CHILD CARE CENTRE

CC SUBMISSION

11 LANCELOT STREET, PUNCHBOWL 2196

PROJECT NO. 22508

ISSUE
C
JOB NO.
22508
DRAWING TITLE
Ground Floor Plan

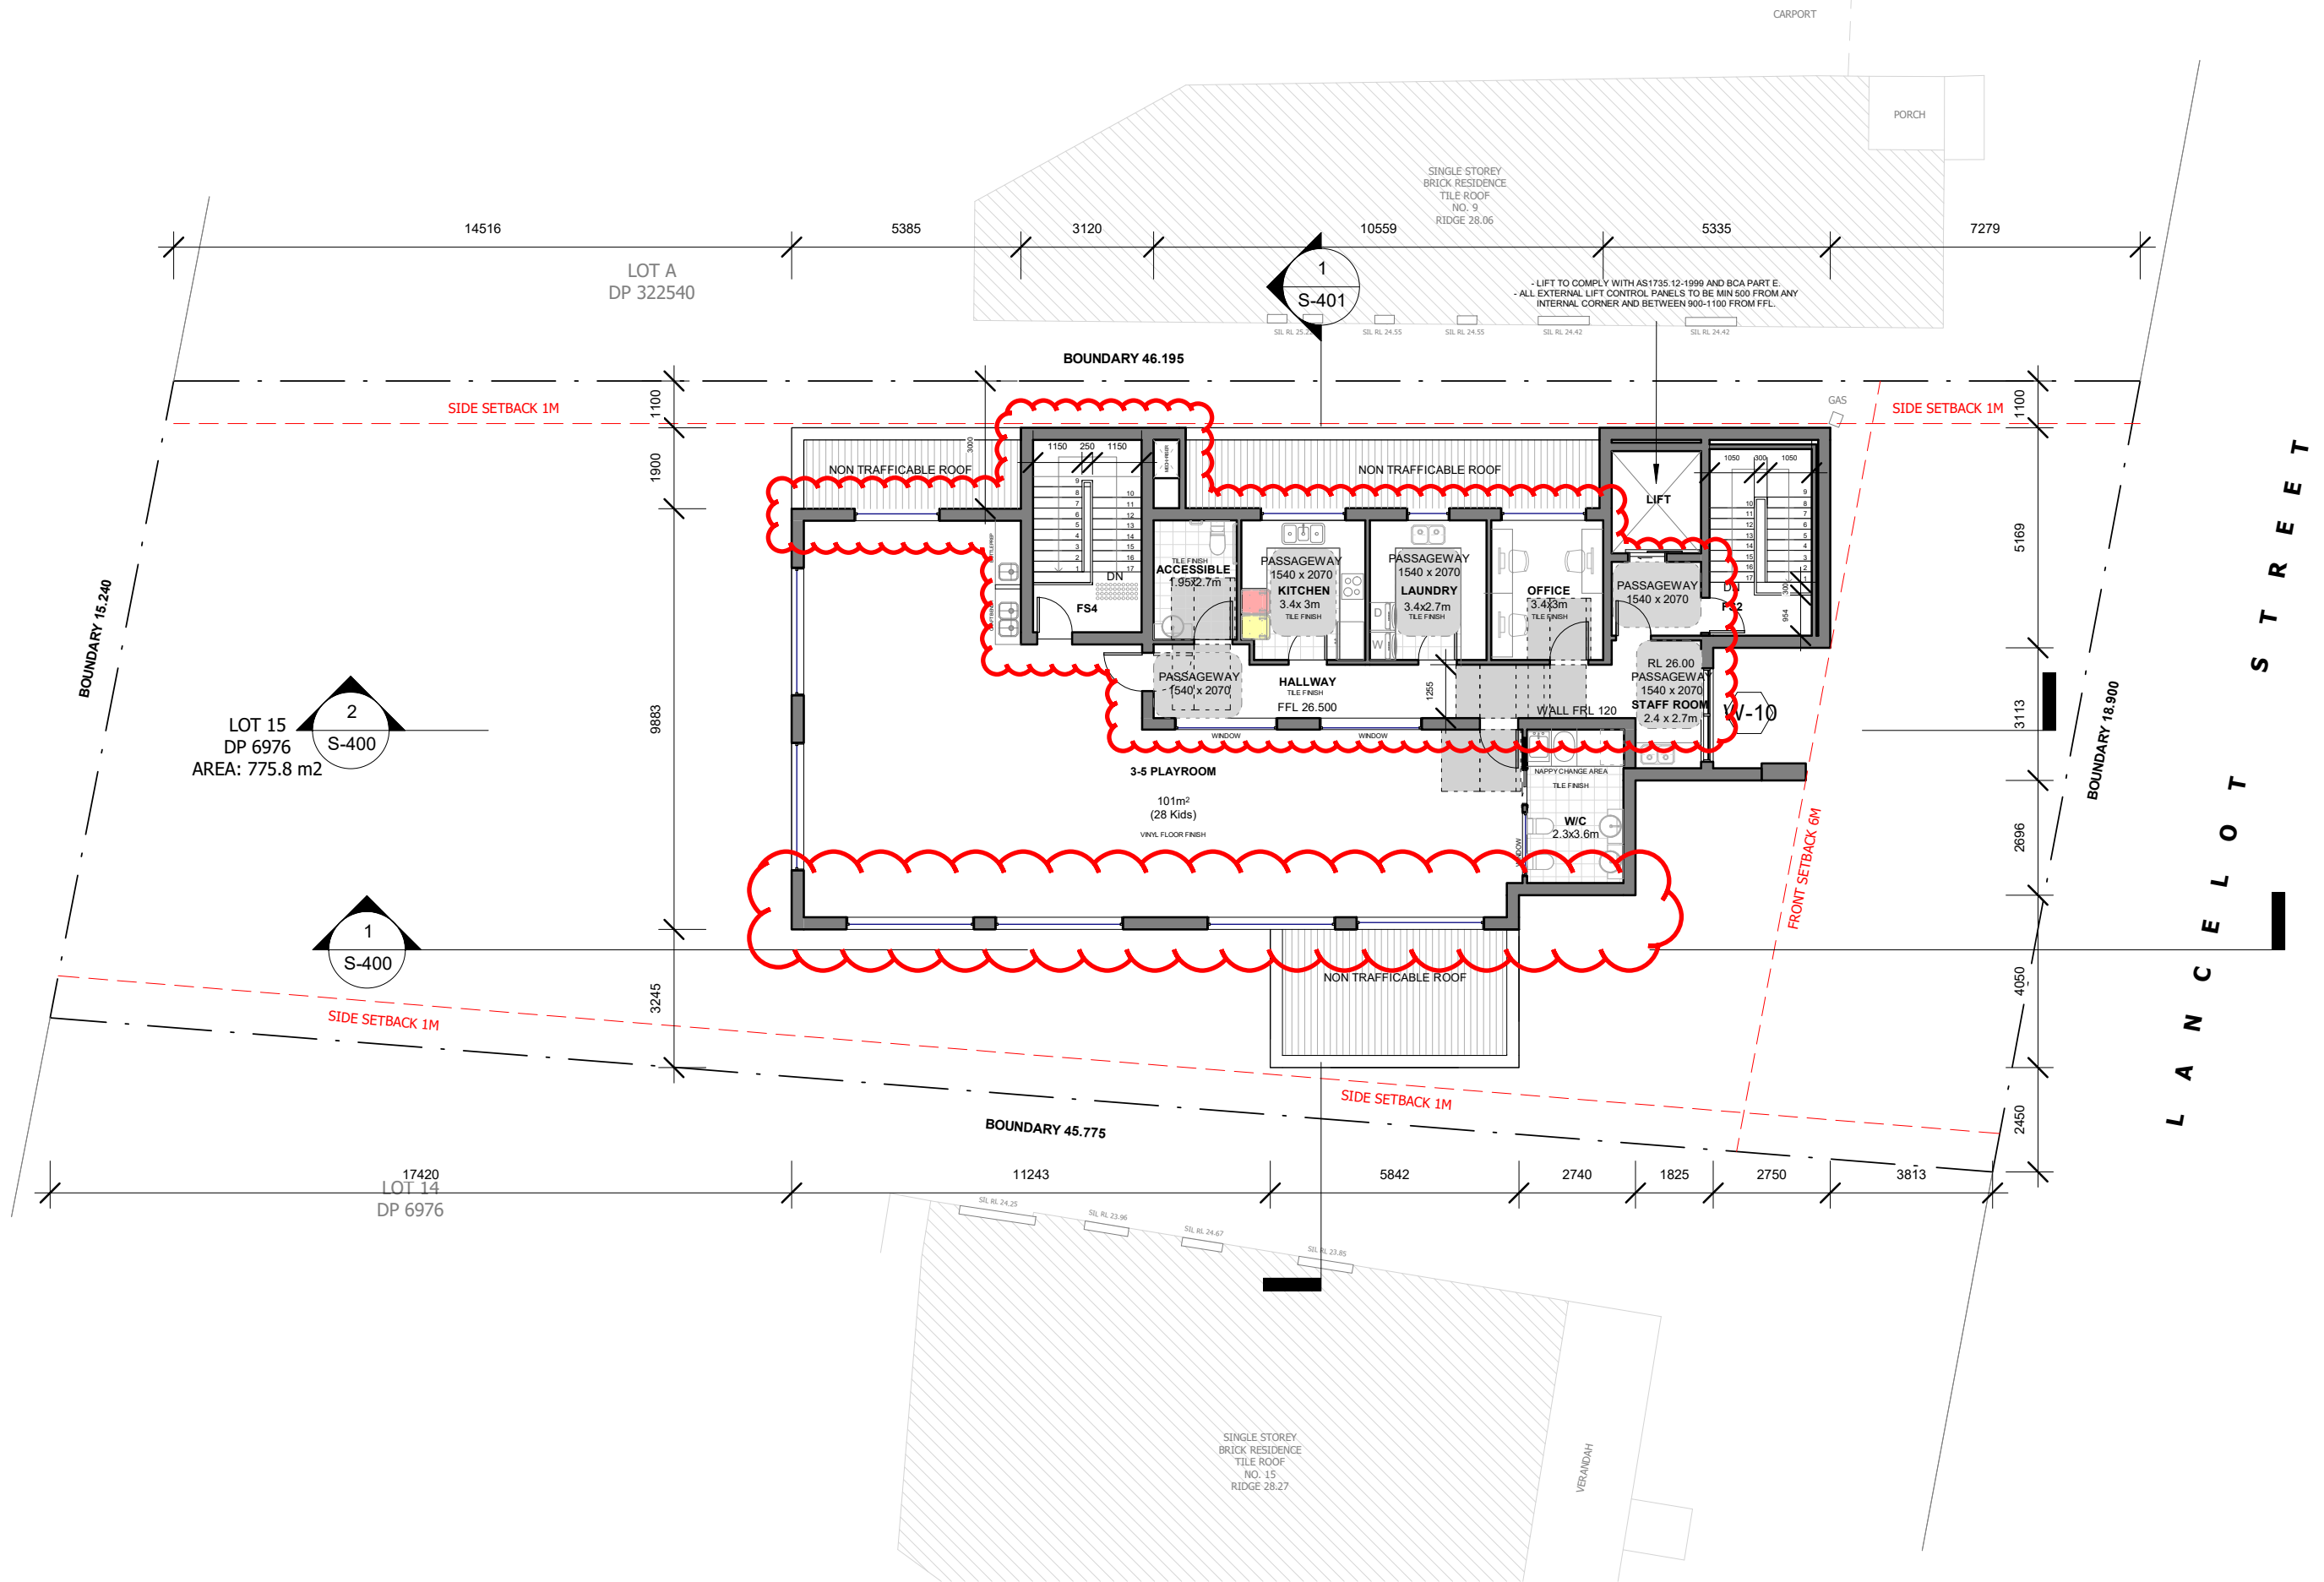
Ground Floor:
-Fire Stair 1 and 2 internally separated
-Front porch extended to allow for separate exit doors from First Stair 1 and 2
-New secondary Fire egress stair from basement (FS3)
-Minor internal configuration other miscellaneous items

ISSUE C	DRAWN BY EB
JOB NO. 22508	CHECKED BY RZ
DRAWING TITLE Roof Plan

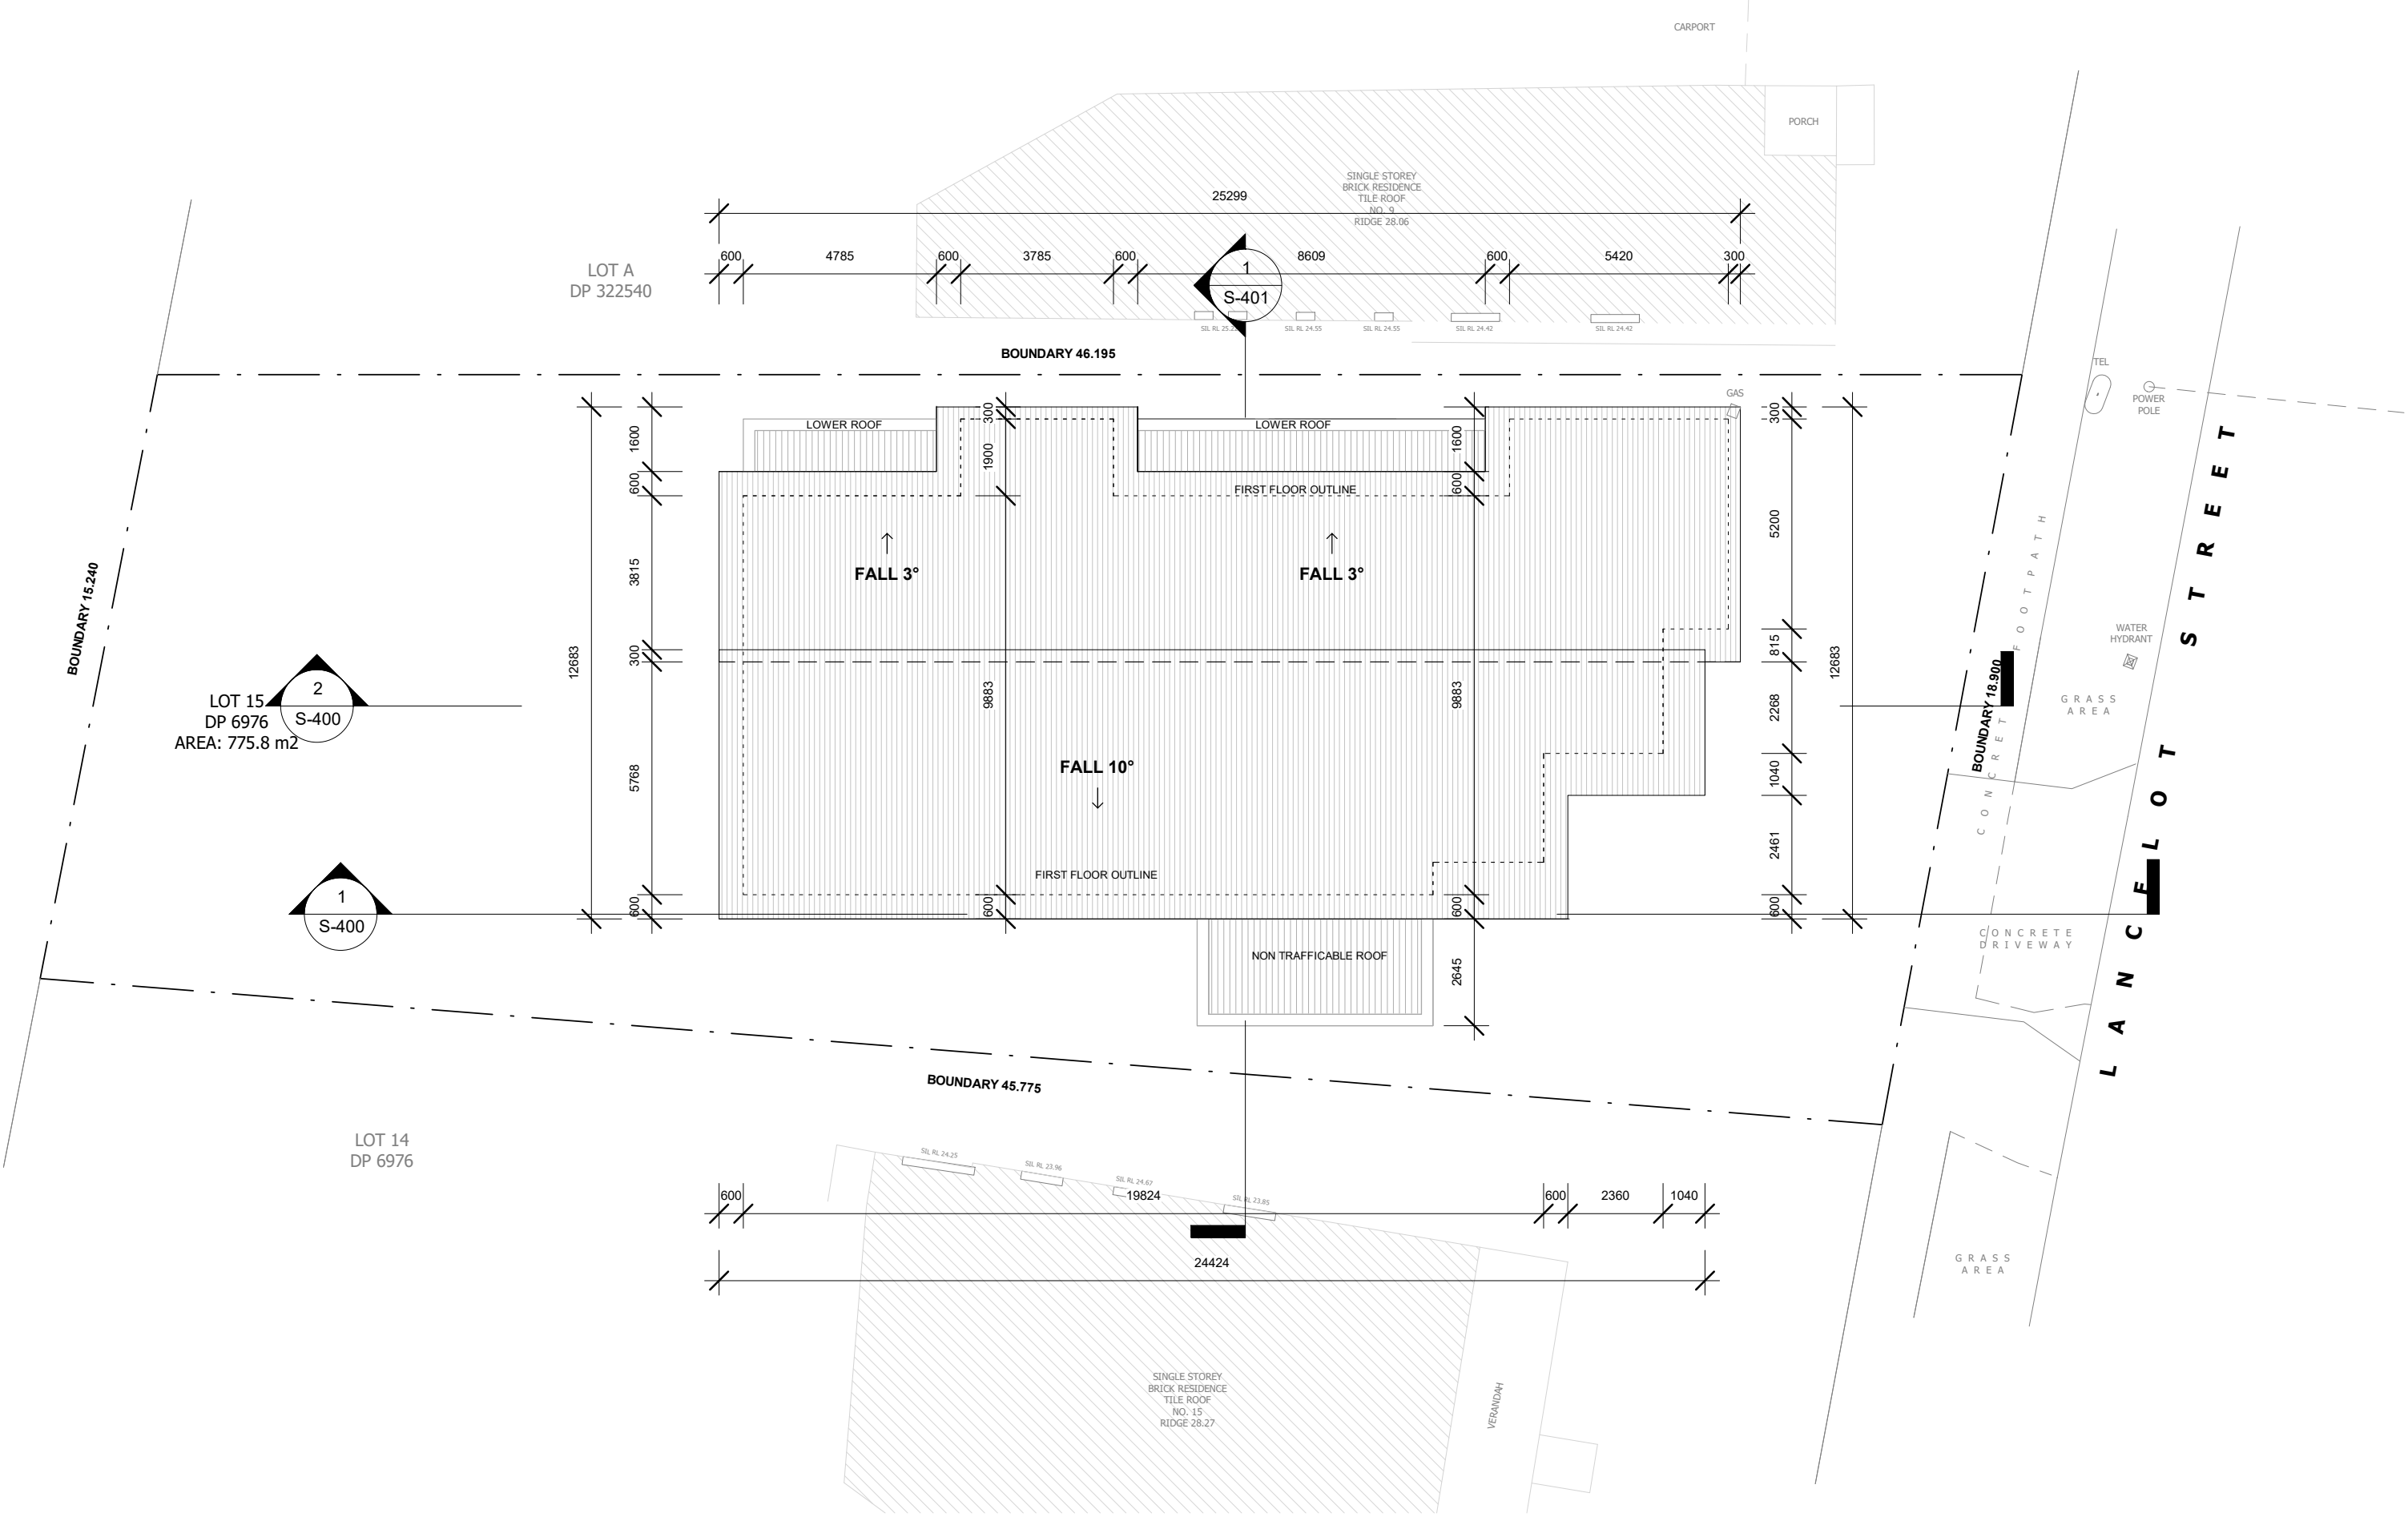
Roof:
-Adjusment to roof to match first floor layout
